DRB CASE ACTION LOG (SITE PLAN FOR BUILDING PERMIT)

DRB Application No.: 07DRB-70215 (SBP)
Project Name: L'IL SQUIRRELS PRESCHOOL
Agent: GARLAN BRYAN ARCHITECT

Site Plan for Building Permit

EAST ELEVATION
SCALE: 1/4" = 1'-0"

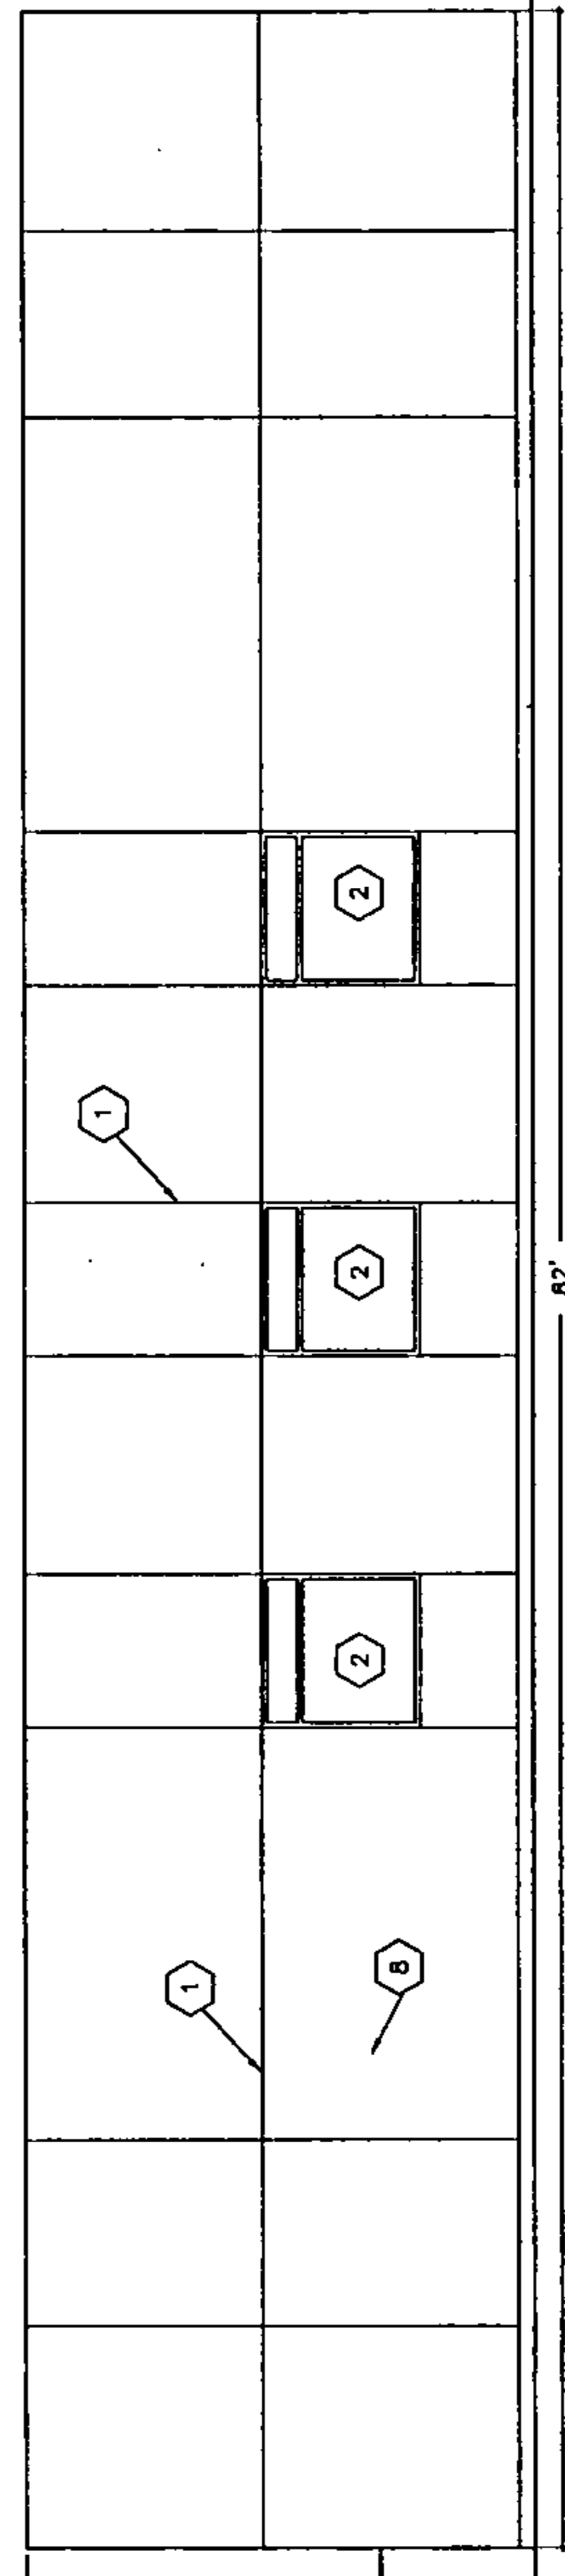
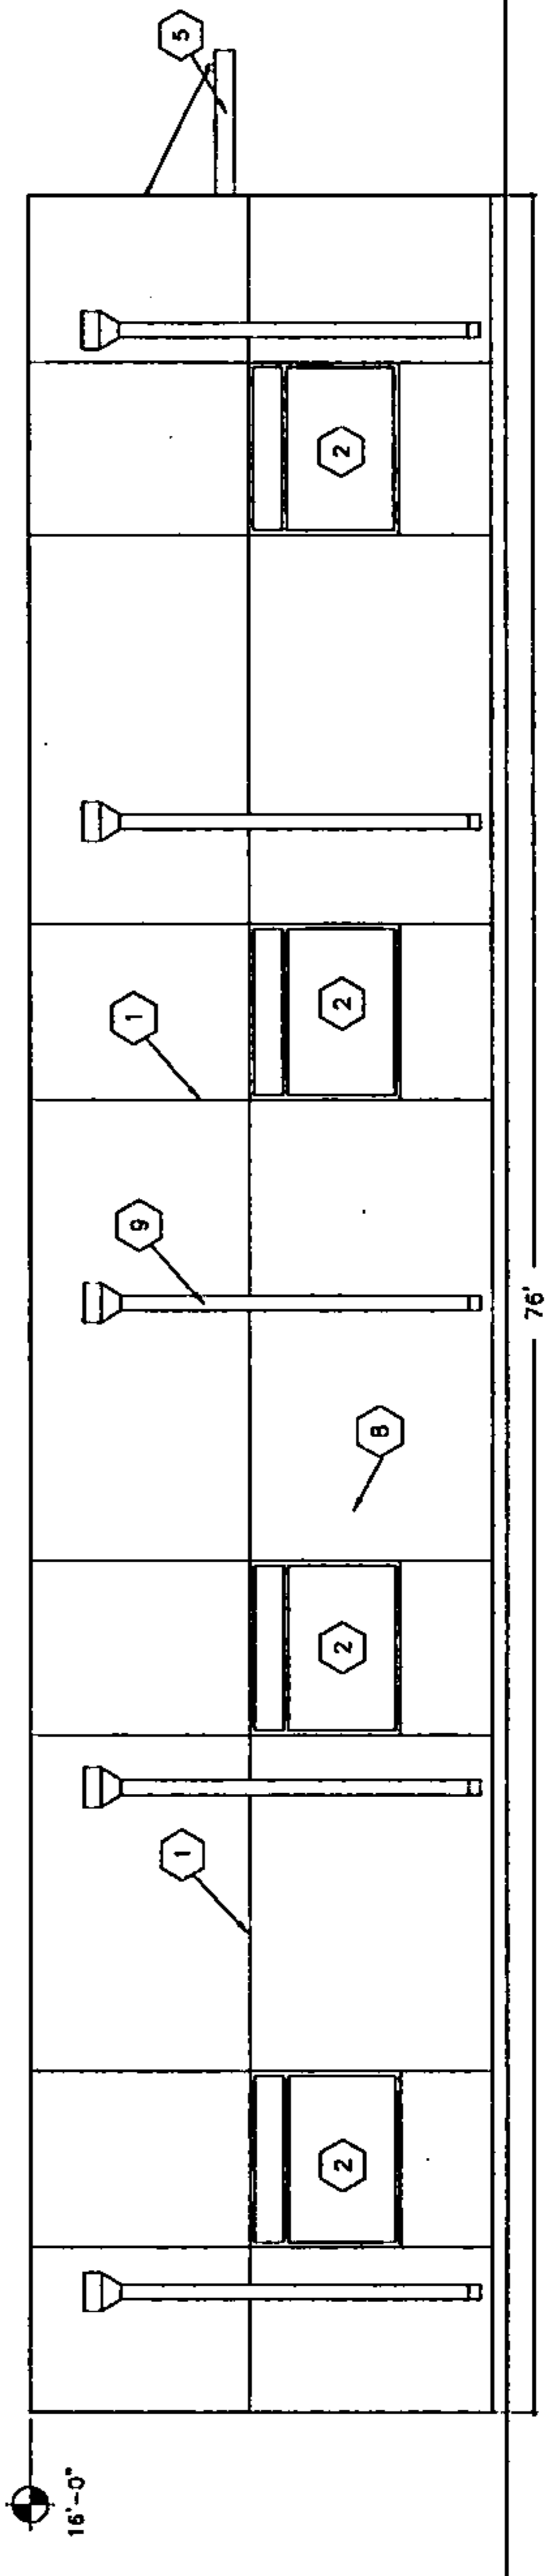
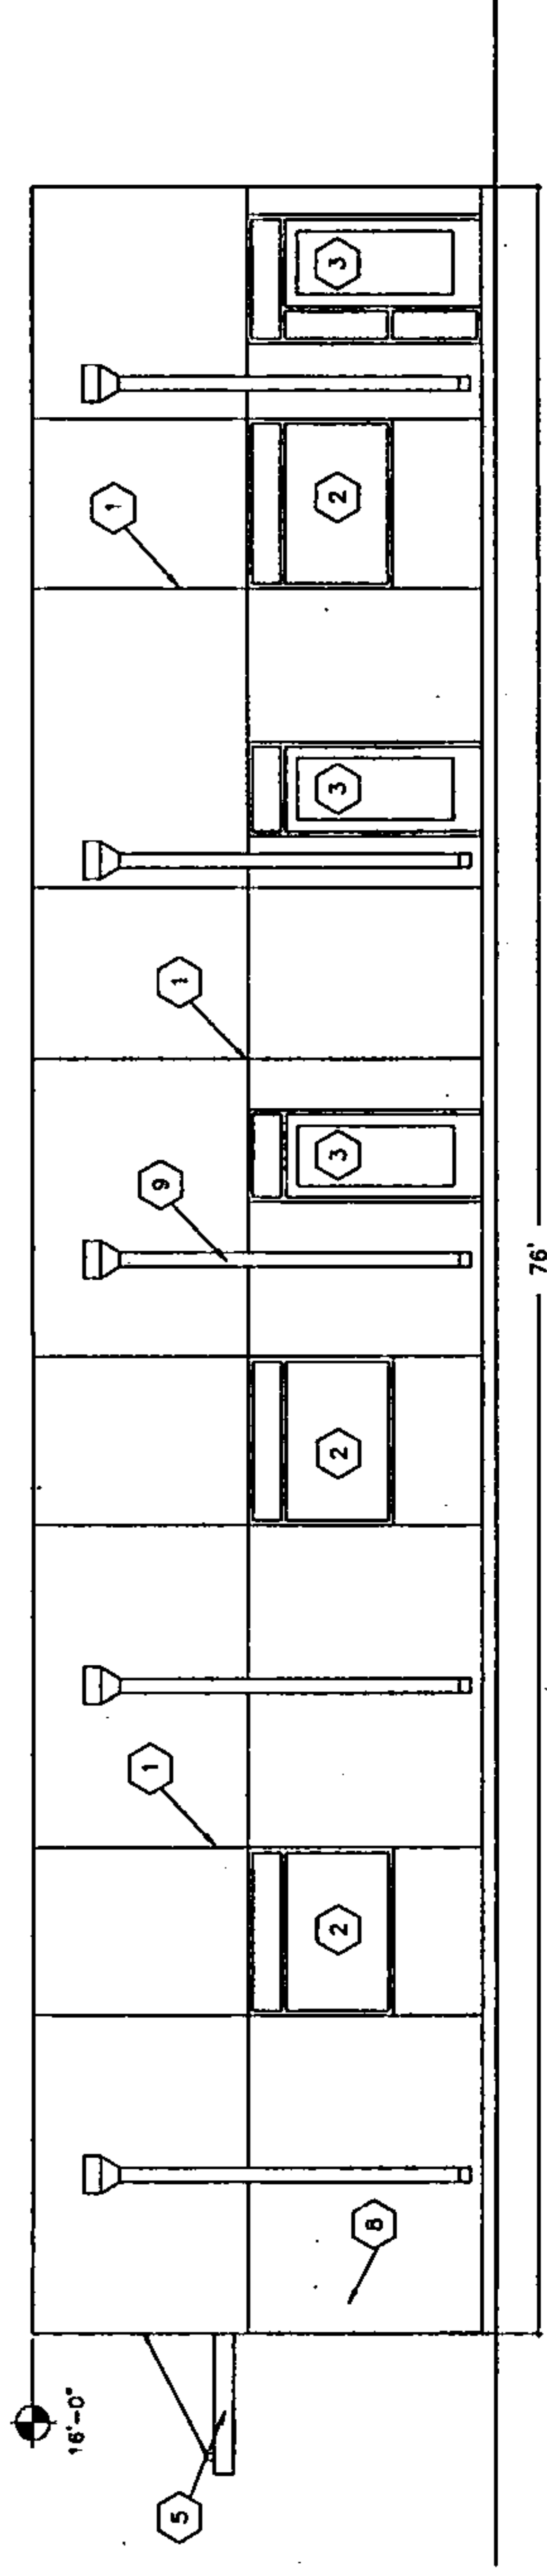
- 7. Santa Fe Brown gravel is required to a minimum depth of 3 inches. Indicate in the note on the Landscape Plan.
- 8. The building elevation sheet is very sparse in details, including specific colors.
